ANN ARBOR HISTORIC DISTRICT COMMISSION

Staff Report

ADDRESS: 235 Buena Vista Avenue, Application Number HDC17-156

APPLICATION: The applicant seeks HDC approval to convert an original window to a door and construct a 6' by 6' deck behind the house with stairs to access the backyard.

Proposed New Deck Floor Plan
235 Buena Vista

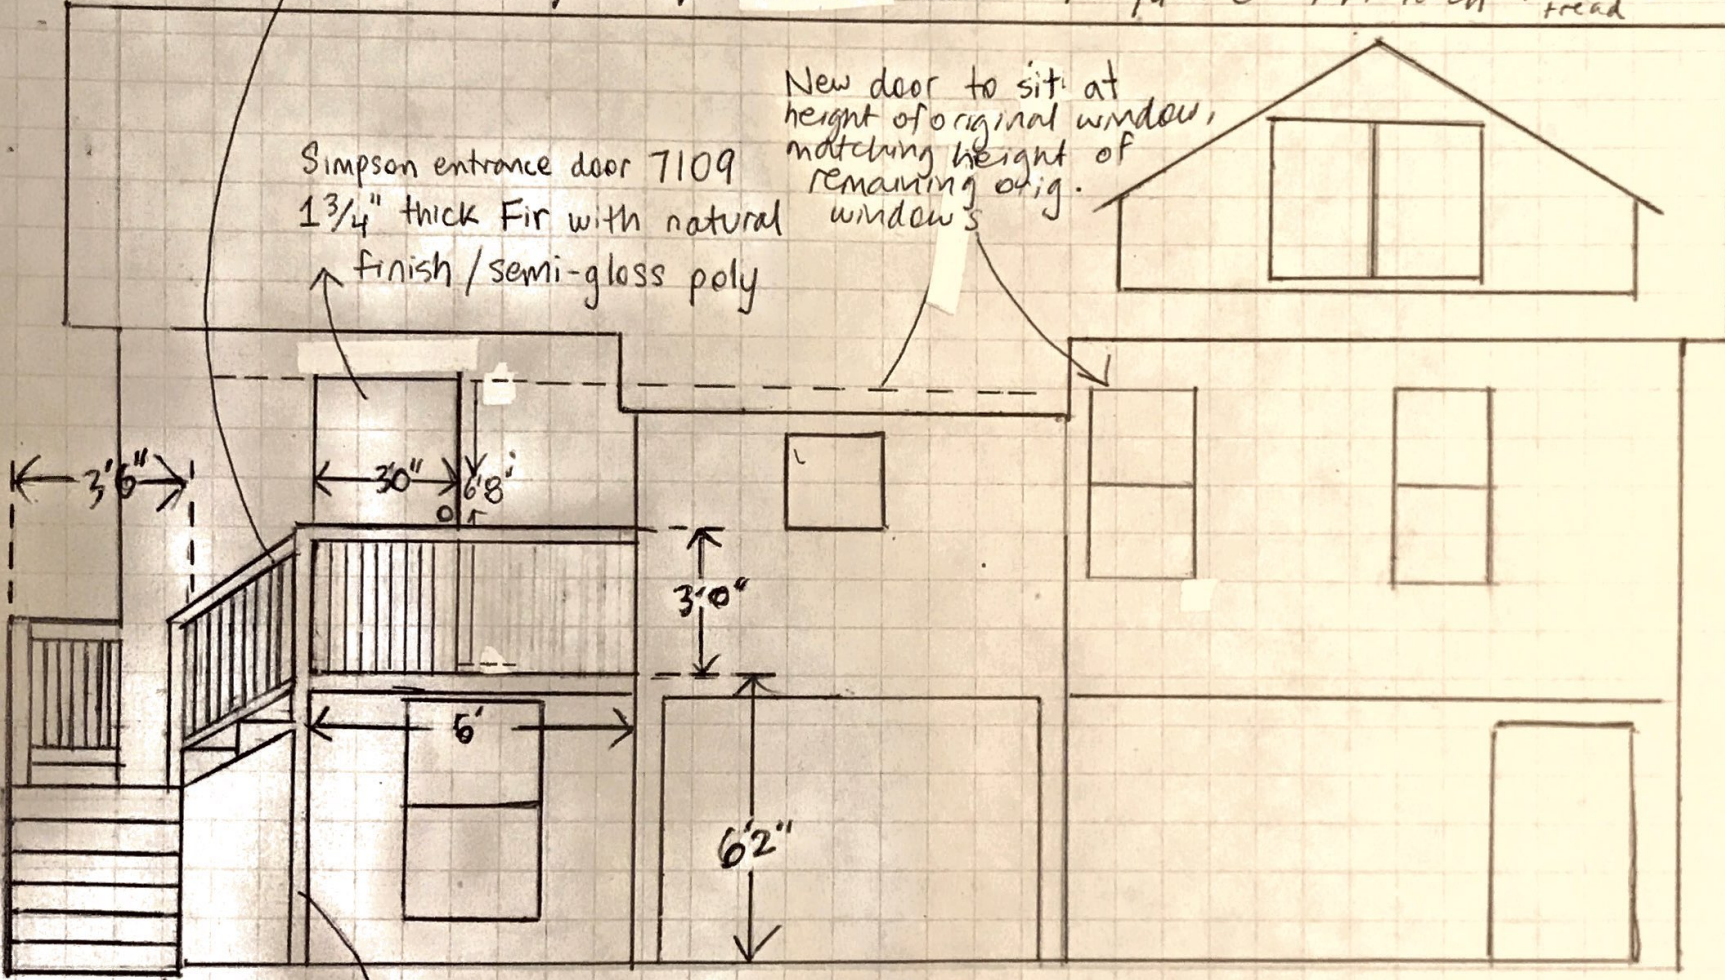
2. The proposed deck is 6' x 6', with stairs down to the backyard and patio. The deck is 62" off the ground, allowing the new door to open directly onto it. A 2" x 8" rim joist ledgered to the house and a 4"x4" post wrapped in composite trim would support the deck. Handrails and guardrails are trex with square 1 1/2" balusters, and decking is trex.

EAST ELEVATION

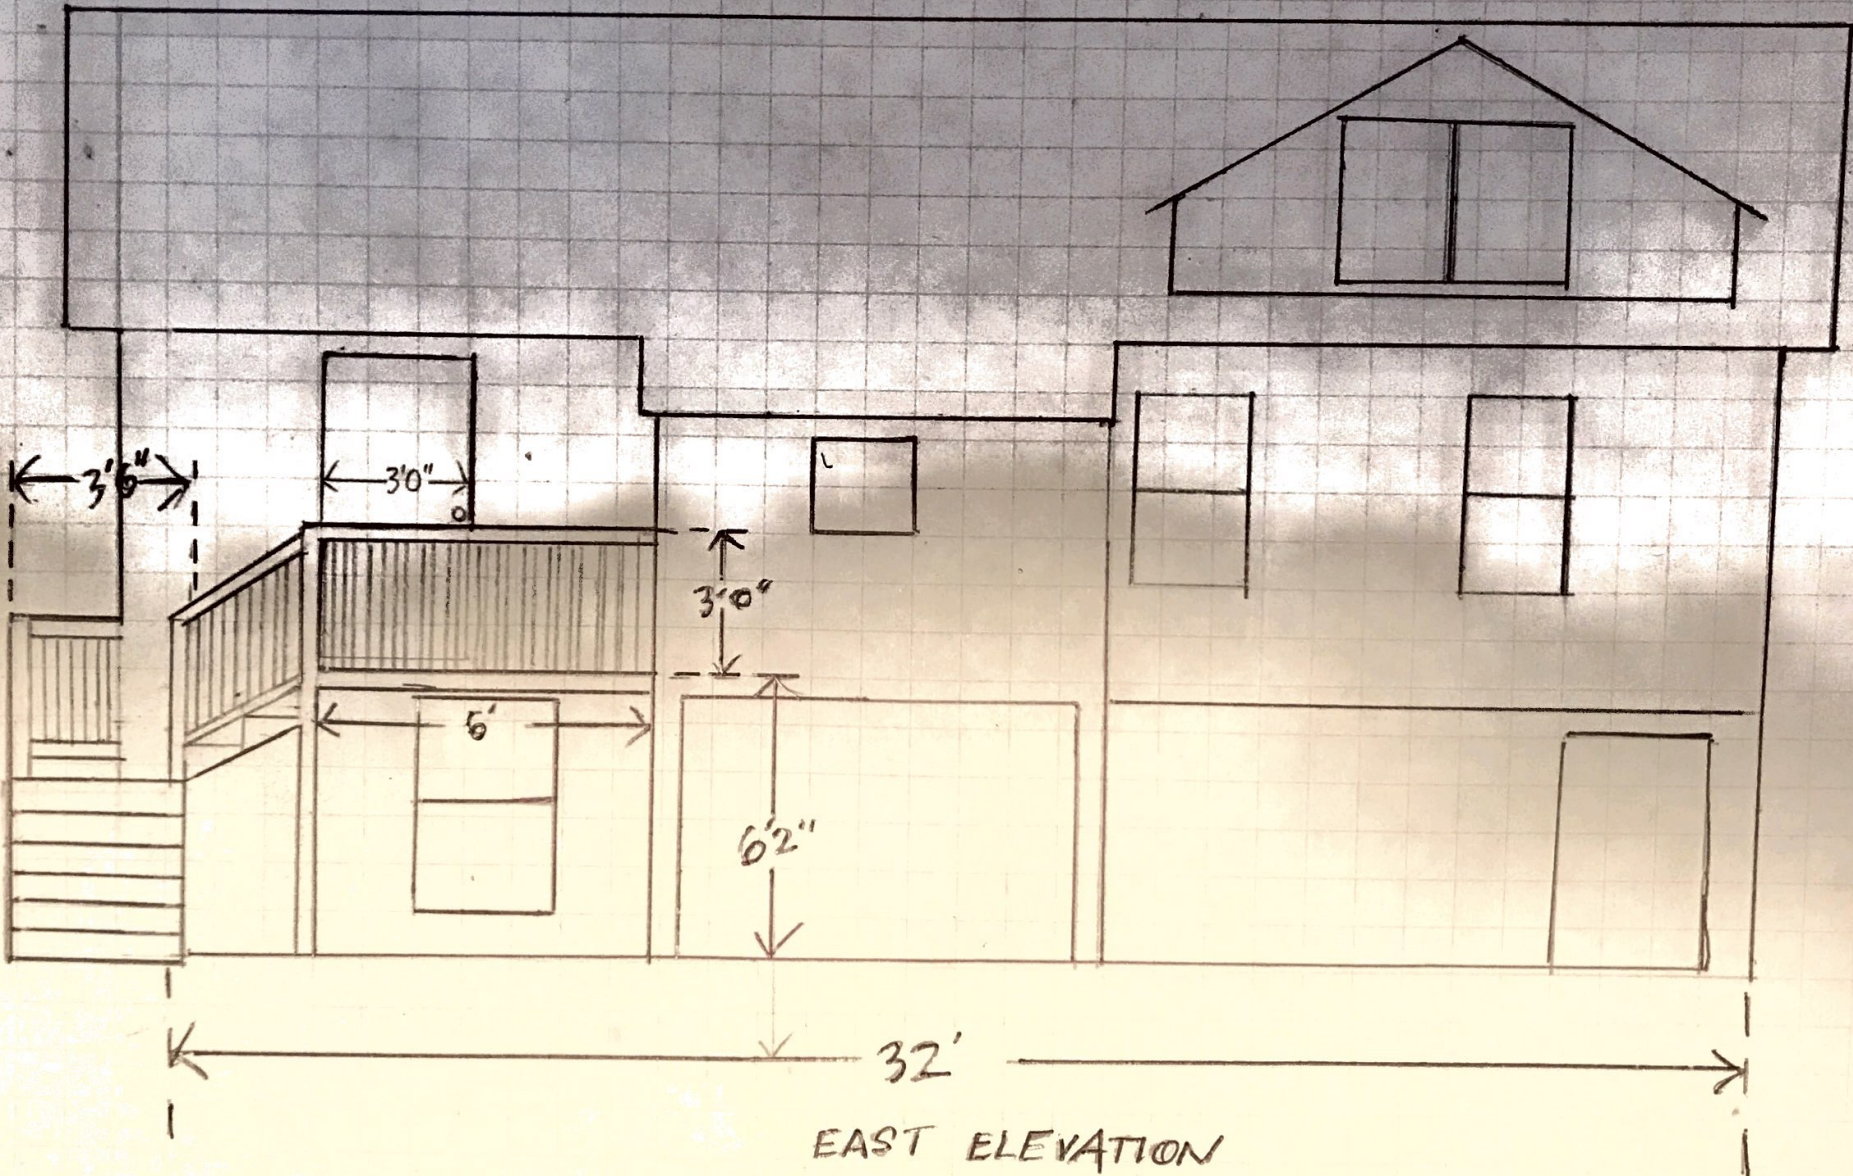
1. The rear elevation of the house has several original four-over-one windows, along with a newer basement window and modern dormer. There is also a small, post-1947 addition on 6" x 6" posts in the center of the rear elevation. The southern window, which appears original to the house, would be replaced by a wood Simpson full-lite door. The header of the door would be at the same height as the removed window and other original windows on the rear elevation.

South elevation - proposed

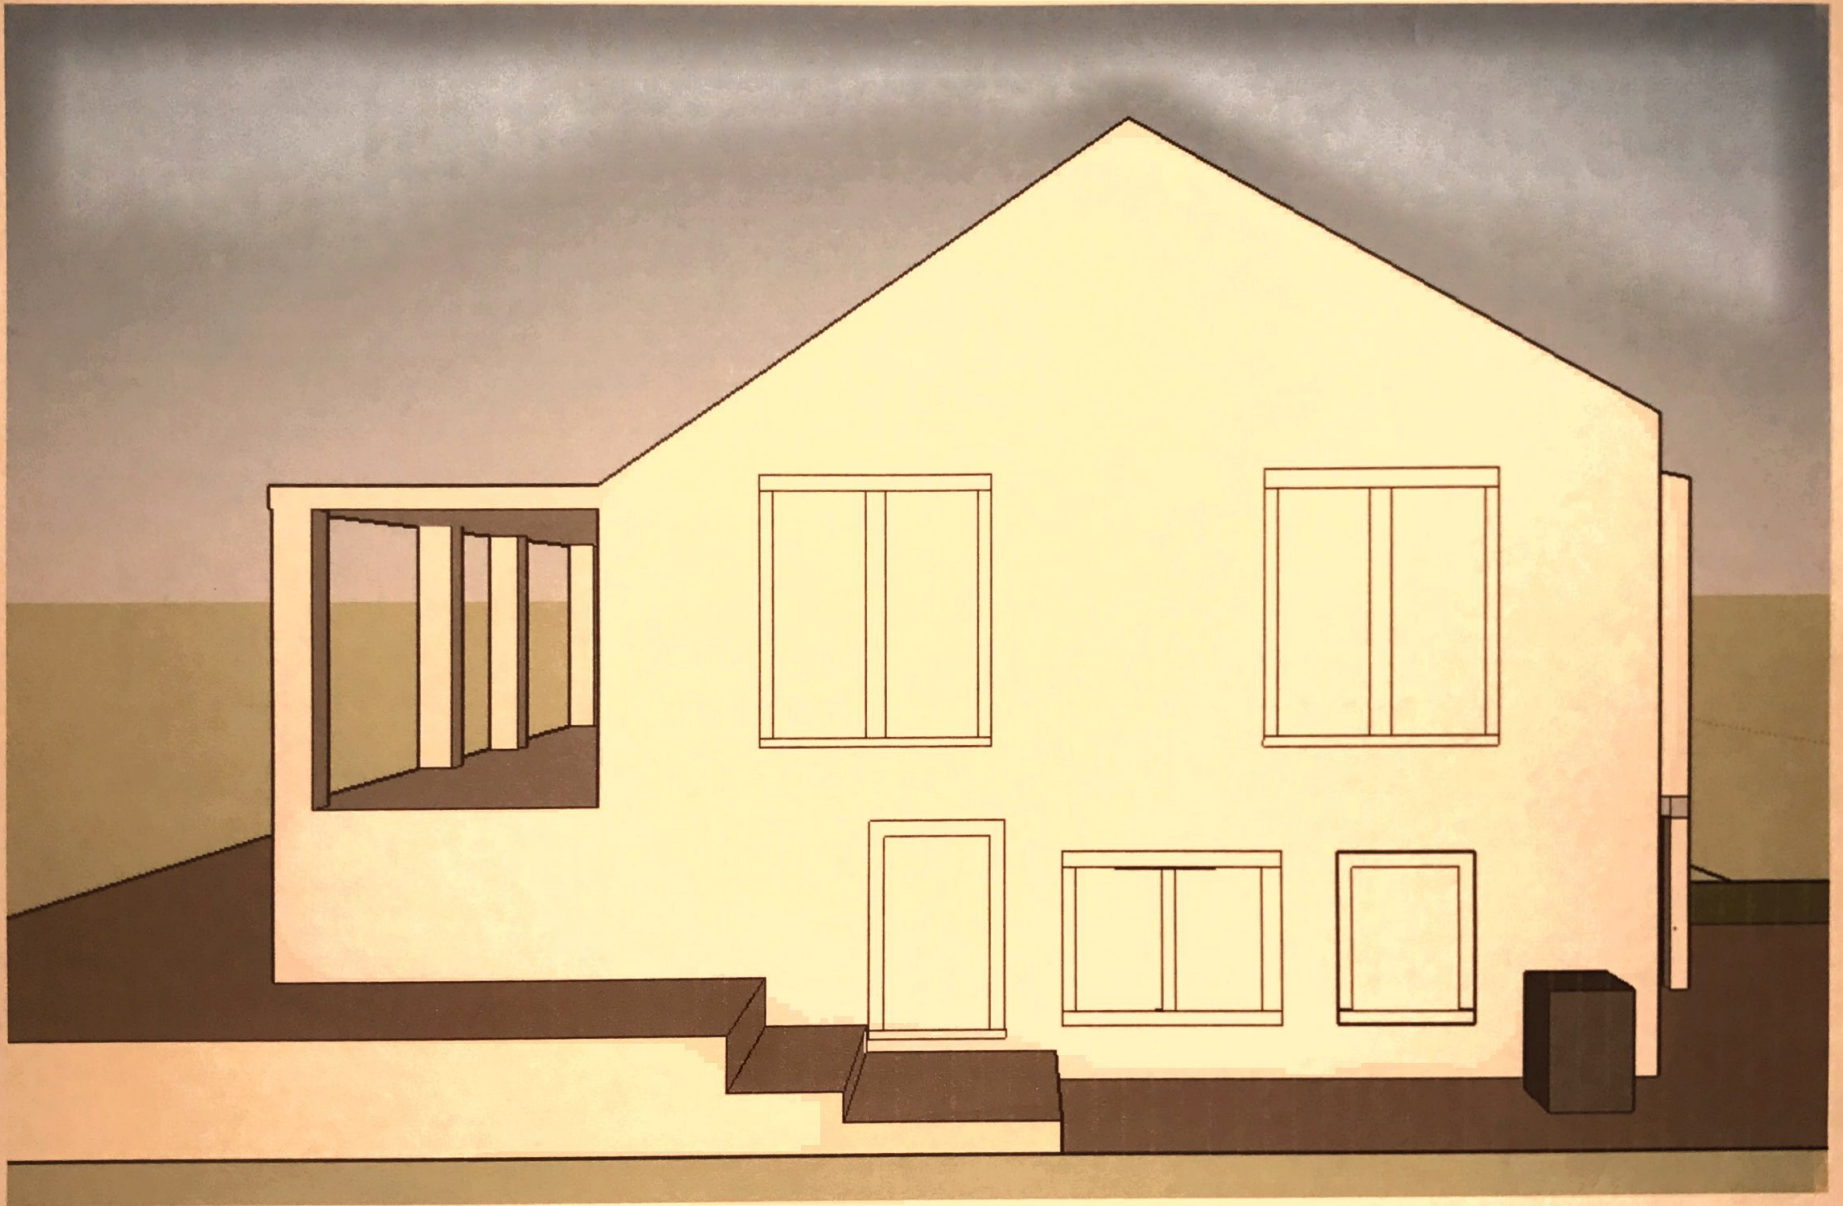
3. The stairs protrude approximately 2' past the sidewall of the house. Since the yard slopes from front to back, from the sidewalk the protrusion is not pronounced, and staff believes it has no negative impact on the historic structure.
